Determination 2009/111

Dispute over a building consent for a house with clay block walls at 10 Greenway Drive, Kerikeri

Plan view of blocks

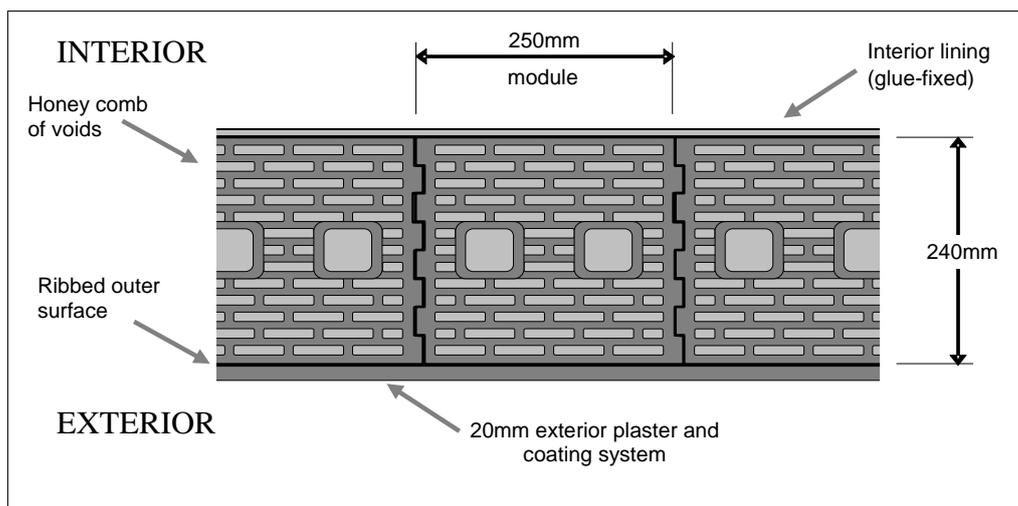
- 2.5.1 The block walls in the house comprise a proprietary wall system that consists of interlocking clay blocks with interlocking dry perp end joints and thin joint laying mortar. The manufacturer produces a range of blocks of varying thicknesses and profiles to suit different applications and junctions. The exterior wall system for this building is shown in the following sketch:
